STAFF RECOMMENDATION
924B South Douglas Avenue
September 16, 2020

Application: New Construction—Outbuilding
District: Waverly-Belmont Neighborhood Conservation Zoning Overlay
Council District: 07
Map and Parcel Number: 105130F00200CO
Applicant: Bram Kane
Project Lead: Melissa Sajid, melissa.sajid@nashville.gov

Description of Project: Application is to construct an outbuilding. The outbuilding will not include a dwelling unit.

924B SOUTH DOUGLAS AVE.

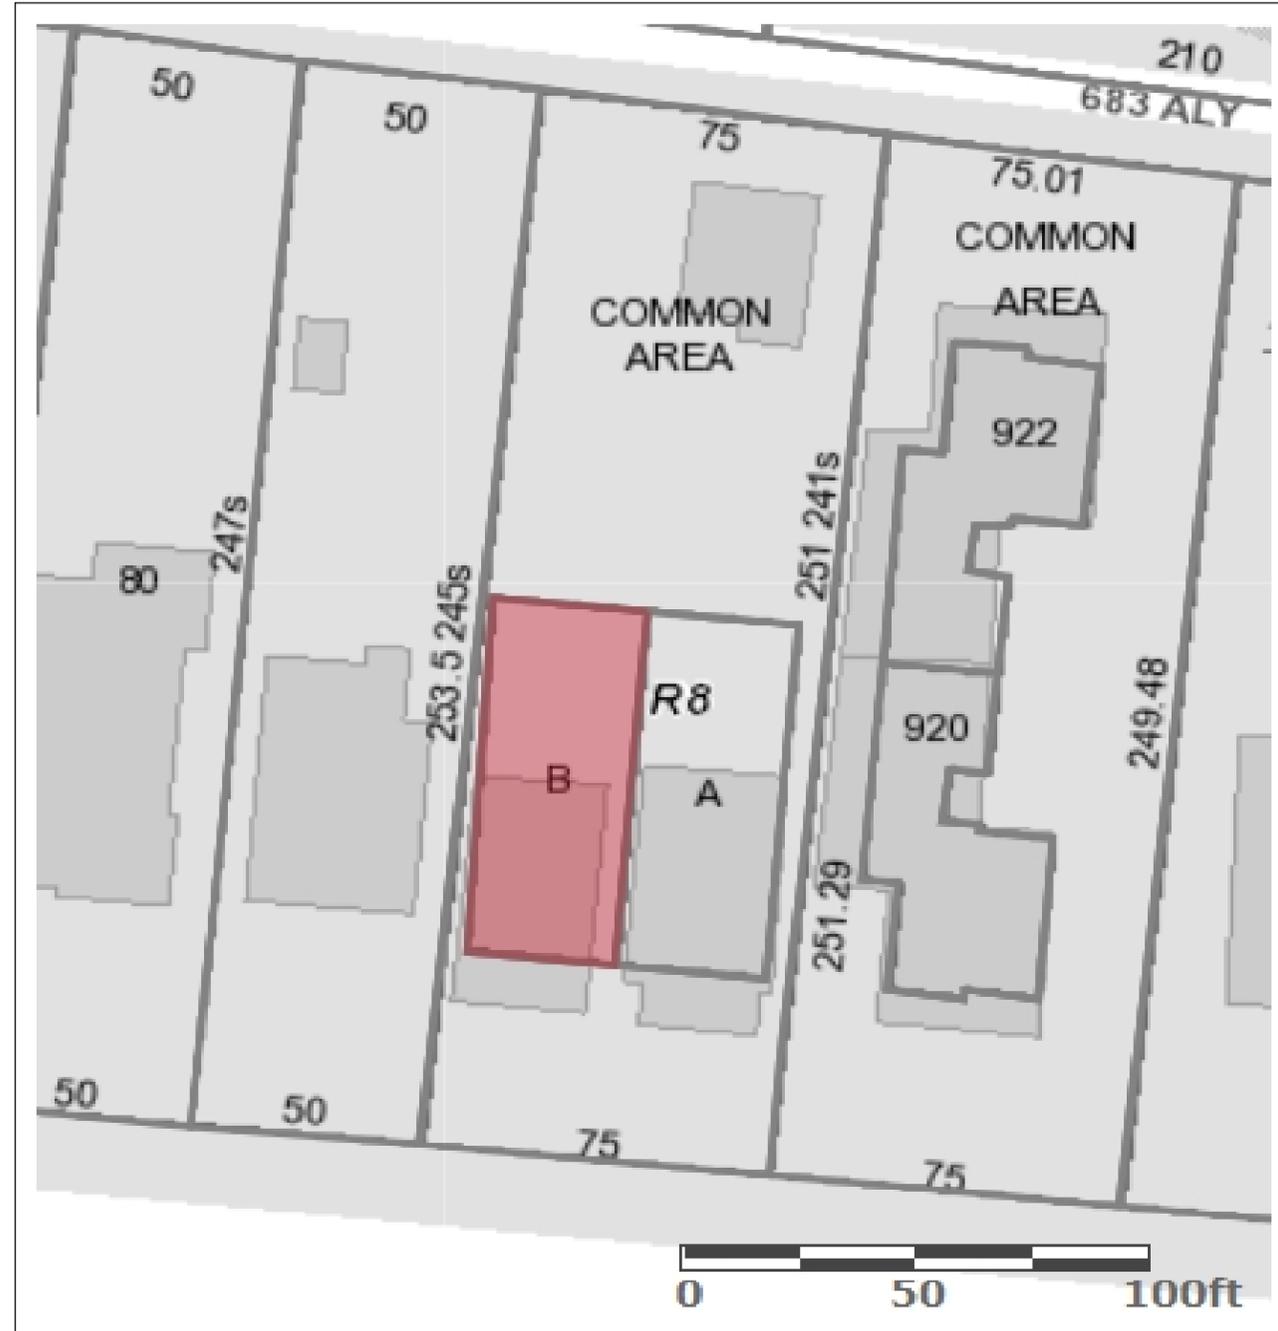
Since the lot is greater than ten thousand square feet (10,000 sq. ft.), the maximum footprint for outbuildings for the entire lot is one thousand square feet (1000 sq. ft.). Unit A already has an outbuilding with a footprint of six hundred seventy-two square feet (672 sq. ft.). The current proposal would add an outbuilding with a footprint of seven hundred square feet (700 sq. ft.), which would make the cumulative footprint one thousand three hundred seventy-two square feet (1372 sq. ft.). This exceeds the maximum permitted by the design guidelines by three hundred seventy-two square feet (372 sq. ft.). As proposed, the addition of the proposed outbuilding does not meet Section III.H.1.b of the design guidelines.

MINIMUM	PROPOSED
Space between principal building and DADU/Garage	20’	~100’
Rear setback	5’	15’
L side setback	5’	6’-9”
R side setback	5’	6’-9”
How is the building accessed?	From the alley or existing curb cut	Alley

The proposed setbacks meets Sections III.H.6 of the design guidelines.
